**RE: Stormwater Management, Freshwater Wetlands, and Flood Hazard Individual Application Review
West Essex Highlands Inc, Inc. Block No. 179, Lot No.32
West Orange Township, Essex County, New Jersey
PB-24-01 West Essex Highlands, Inc.**

At the request of attorney Bruce Afran, counsel for objectors and We Care NJ Corp., Princeton Hydro has performed an independent technical review of the aforementioned development located in West Orange Township, NJ. The project is also the subject of a NJDEP Flood Hazard Area permit and Freshwater Wetland Permit, NJDEP File and Activity No. 0722-04-0001.1, LUP230001. The initial Flood Hazard Area permit had been withdrawn, and the new Flood Hazard Area permit application was submitted on July 22, 2024. Princeton Hydro also reviewed the latest (third) submission of the Freshwater Wetlands permit application. A revised submission was provided to the NJDEP on October 2, 2024. Princeton Hydro has updated our review letter based on the latest submission.

Figure 1: Proposed Grading Plan with Blue Arrows showing the existing drainage path and the red arrows showing the proposed drainage paths and how the runoff is being diverted from the wetlands.

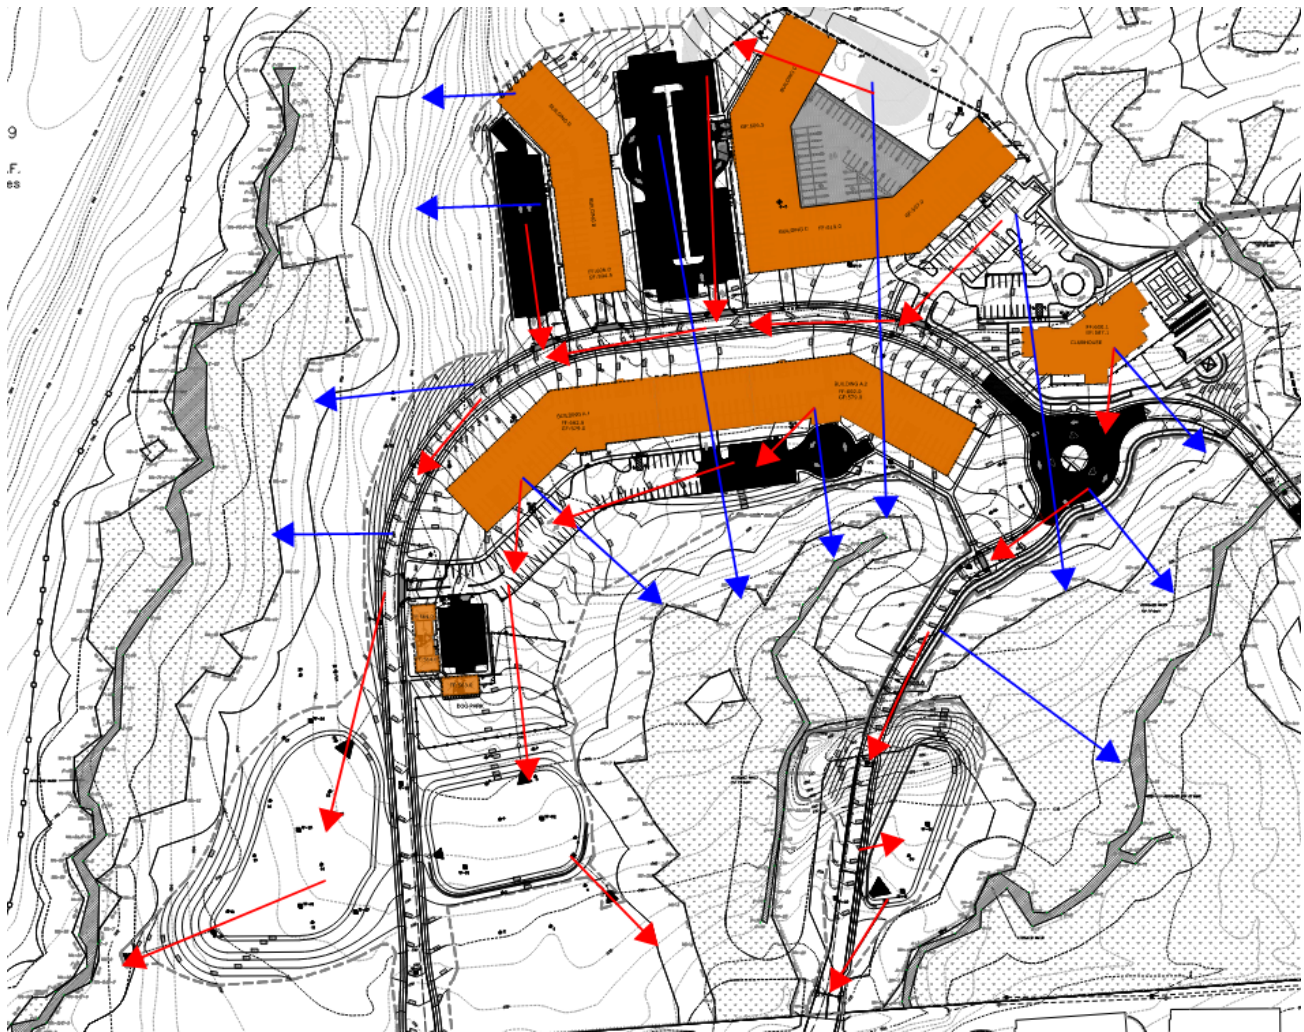
While the project is not compliant with the Groundwater Recharge requirements due to sufficient soil testing, it also reroutes a significant portion of the stormwater runoff in a manner that changes the flow

patterns from the existing conditions. Under the existing conditions, the stormwater runoff sheet flows evenly from the site to the existing wetlands. This flow of water helps to hydraulically support the conditions of the wetland. The proposed improvements will collect and convey the stormwater runoff through the stormwater system and the runoff will be discharged much further downstream. The current design does not replicate the existing groundwater hydraulics in either magnitude or pattern, and the recharge that it does offer concentrates the groundwater recharge much further downstream in the watershed. The proposed development will greatly reduce the amount of stormwater that is discharged (via overland flow and through the groundwater) to the upstream portions of the existing onsite wetlands, as demonstrated in Figure 1. This reduction of received stormwater runoff would cause permanent damage to the wetlands.

Figure 2: Existing Conditions Drainage Path for POA-2, demonstrating how the analysis stops approximately 700 feet short of the POA location.

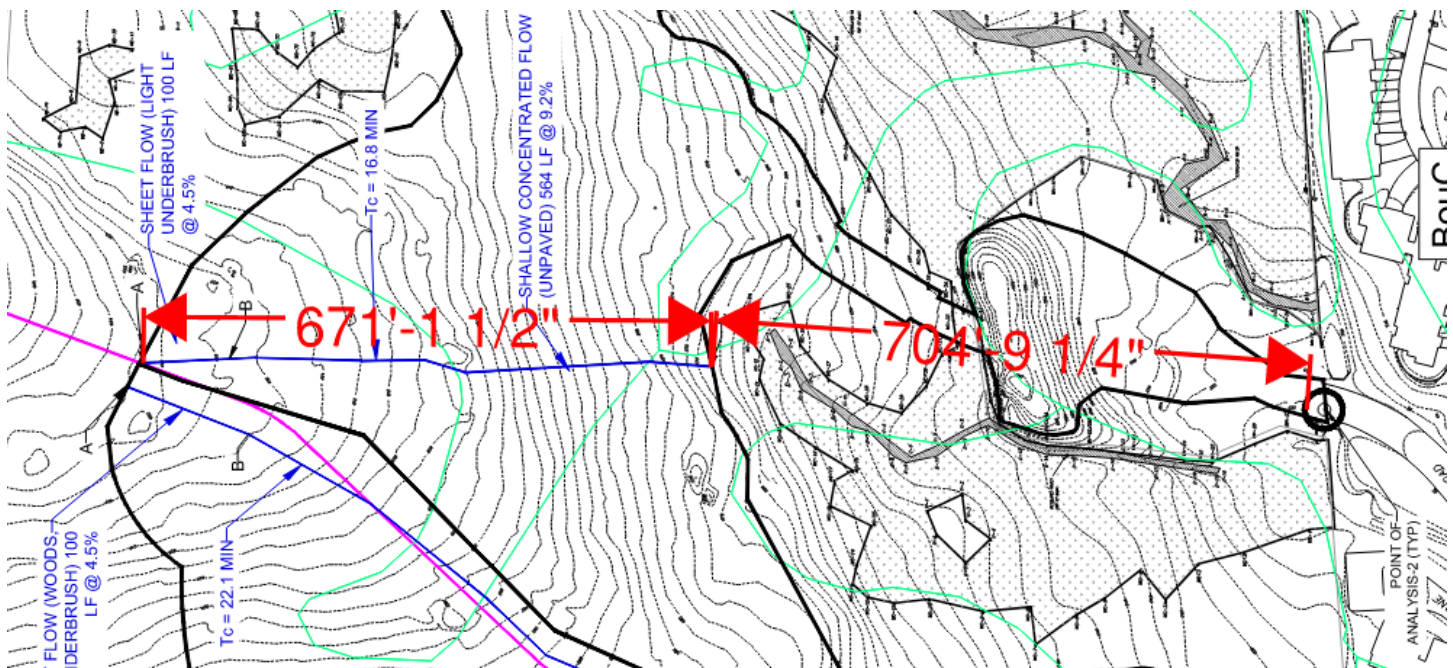
Furthermore, there is a substantial routing error in the stormwater model. The site is broken down into three points of analysis (POAs). After reviewing the drainage patterns in existing and proposed drainage plans, Princeton Hydro has concluded that there should be four POA's not three. POA2 has two distinct discharge locations on Warner Road and Kuzik Drive. The two roadways are over 500 feet apart. Their flows cannot simply be combined. The drainage area analysis completely ignores any flow in the existing and proposed condition at Kuzik Road. The flows at both points need to be analyzed separately to make sure the stormwater runoff quantity standards as per N.J.A.C. 7:8-5.6 (c). The current design ignores flow at Kuzik Road and risks causing a significant flooding issue unless a separate POA at Kuzik Road is included in the analysis. The current analysis cannot demonstrate that the flow at Kuzik Road meets the peak flow reductions for the 2-, 10- and 100-year storm. The report and modeling give the false appearance that the proposed design meets the required peak flow reduction rates. Only after the fourth POA is developed and analyzed can the model confirm that the design is compliant. It must also be noted that the existing conditions drainage path for POA 2 stops approximately 700 feet short of the actual analysis point which just another error in the analysis that would need to be addressed as shown in Figure 2 below.
